ADDENDUM NO. 1
CONTRACT DOCUMENTS AND TECHNICAL SPECIFICATIONS
September 1, 2026

PROJECT: New 2.0 MG Ground Storage Tank at Fire Tower Rd (Brogdon)
Calhoun Project No.: 358
OWNER: City of Calhoun
BID DATE: Friday, September 4, 2026 at 10:00 a.m.
TO: All Bidders

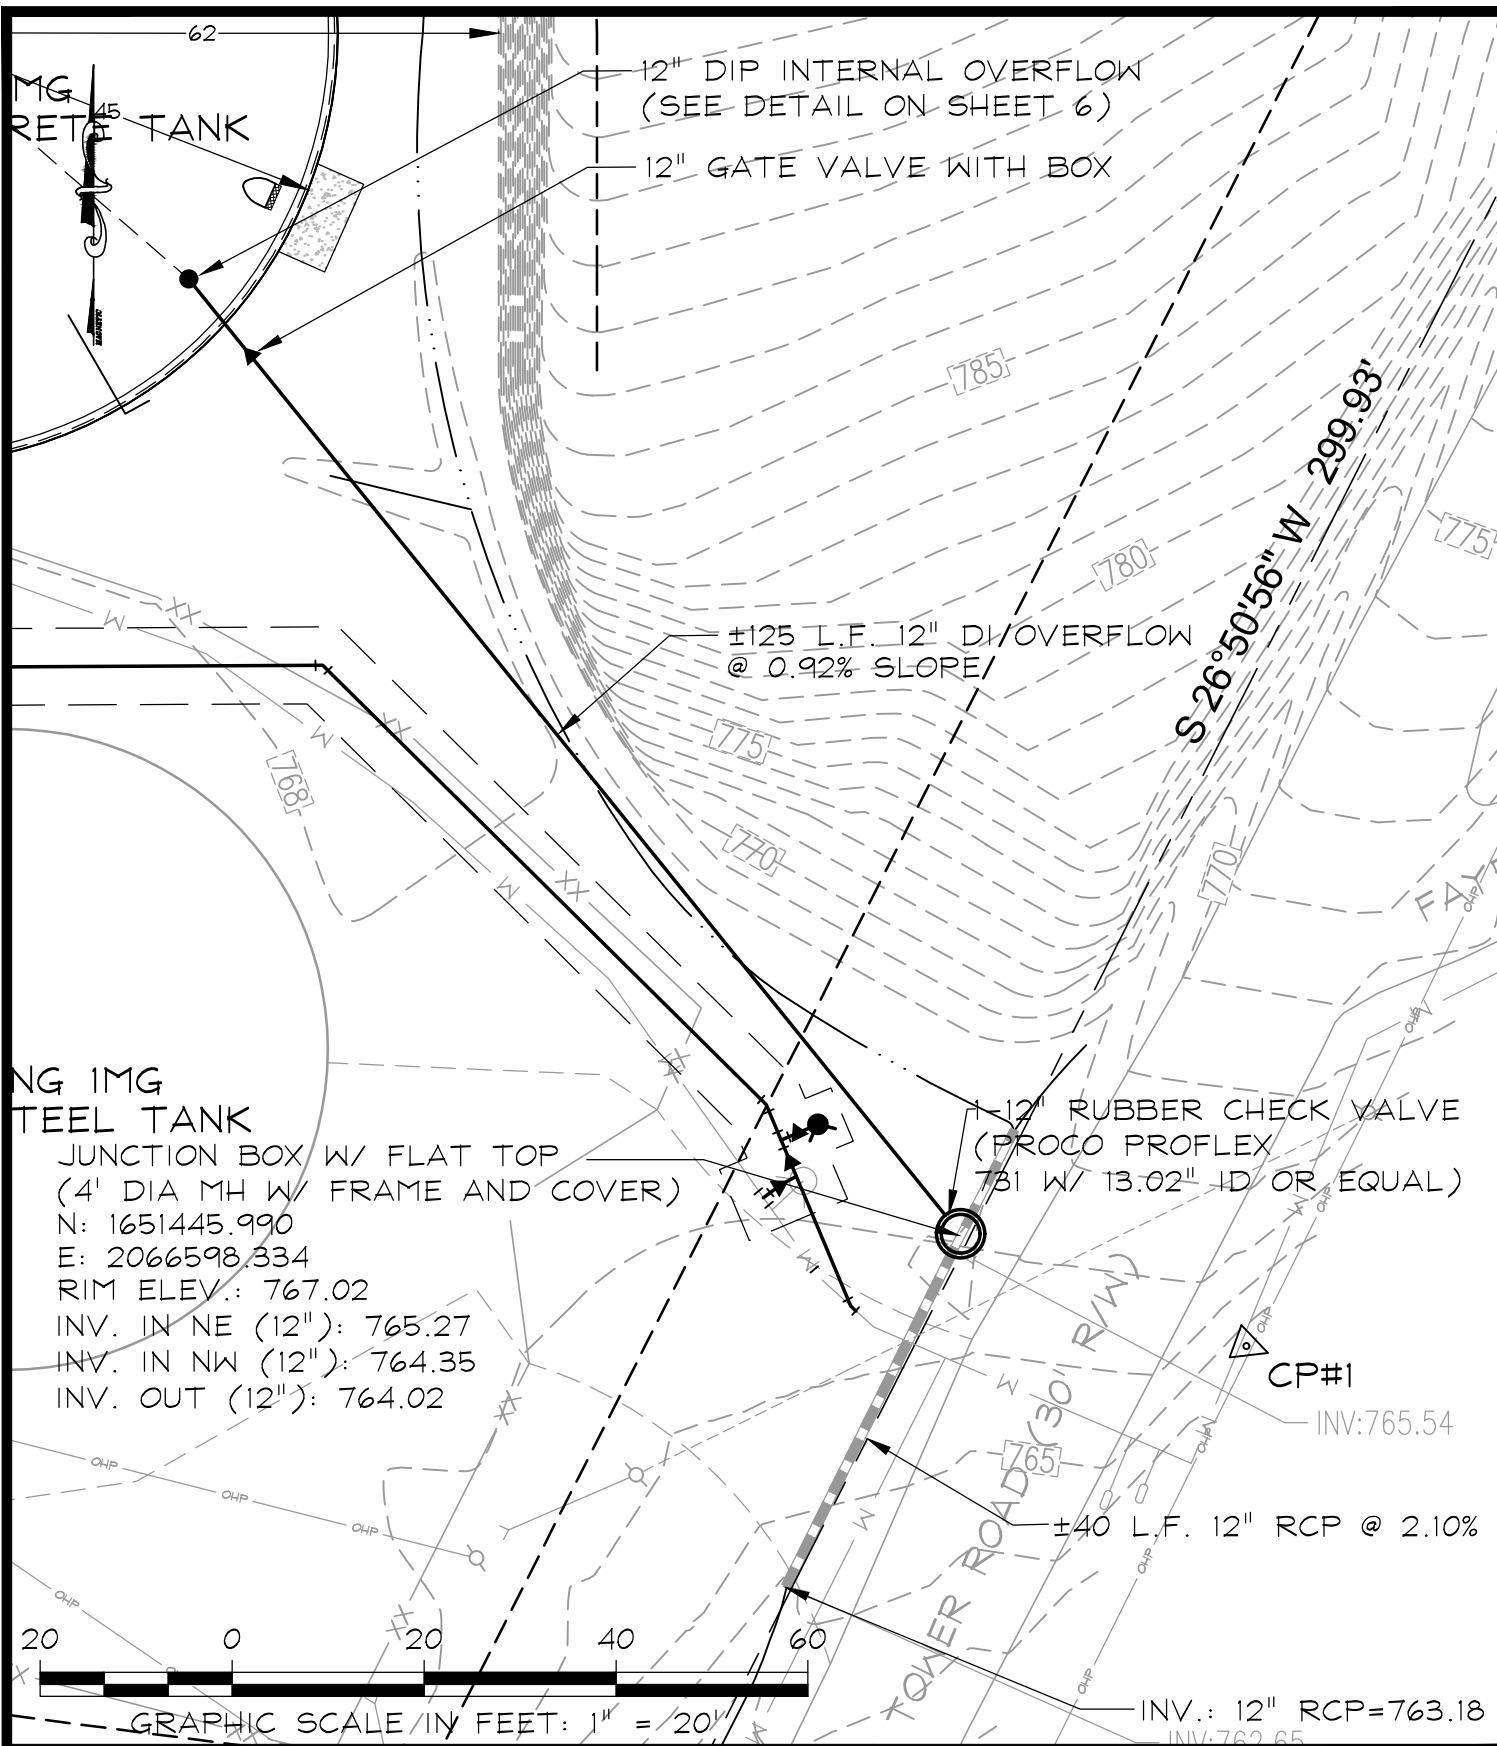
Base bid items will remain unchanged by this addendum. However, the Owner wishes to obtain add-on pricing for the Internal Tank Overflow and 12" Rubber Check Valve that were eliminated in the rebid modifications dated August 3, 2026. Contractor shall reference the strike-through details on Plan Sheets 6 and 7. A plan view depiction has also been attached to this document. **A revised bid form will not be issued.** Contractor should hand-write prices at the bottom of the "Alternate Bid Item" spreadsheet on page 00400-5 using the format below.

The following paragraphs shall be included under the Measurement and Payment section in their respective order. Any work beyond the 12" DI 90° bend (portions outside the tank) should be excluded for the lump sum price. Instead,

those items will be eligible for payment using line items already established in the base bid (i.e. Item #13, 14, 15, 18, and 32).

“7. Internal Tank Overflow: Measurement of the 12” DIP overflow assembly shall be measured on a lump sum basis. More specifically, the bid item should include the interior flanged ductile iron piping, flared fitting, 90° bend, ceramic epoxy coating, pipe brackets, and concrete encasement.”

“7. Internal Tank Overflow: Payment for the 12” DIP internal overflow should cover all labor, equipment, and materials needed to safely and securely install the assembly as detailed in the drawings, if the Owner decides to select this optional add-on.”
